# Access Compliance Report

## Public Rights-of-Way

### (Curb Ramps)

| ADA ID: 9B81CEA29F76 | Ramp Type: PerpDiag      | Initial Pass/Fail: Fail    | Overall Compliance: No |

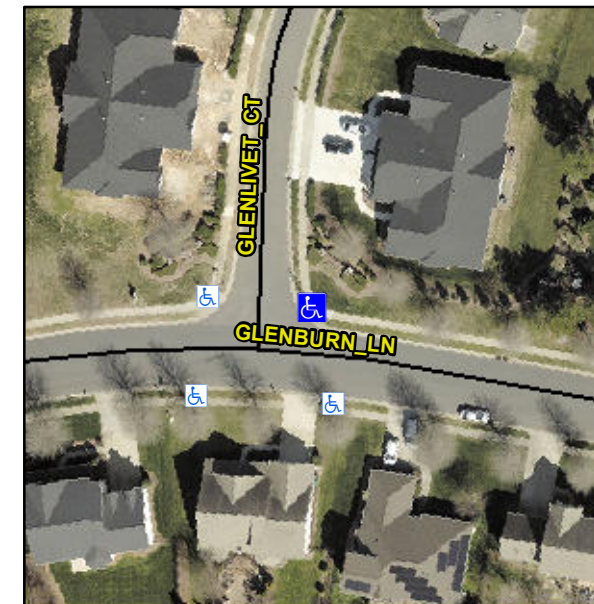
**Not Found, R304.5.1, R304.2.2, R304.5.3**

| Compliance | Description           | Data | Compliance | Description                 | Data  |
|------------|-----------------------|------|------------|-----------------------------|-------|
| N/A        | Ramp Length (in)      | 46.5 | No         | Ramp Slope (%)              | 10.4  |
| No         | Ramp Width (in)       | 47.0 | No         | Ramp XSlope (%)             | 5.3   |

**Remove & Replace Curb Ramp With Two New Directional Ramps or Equivalent.**
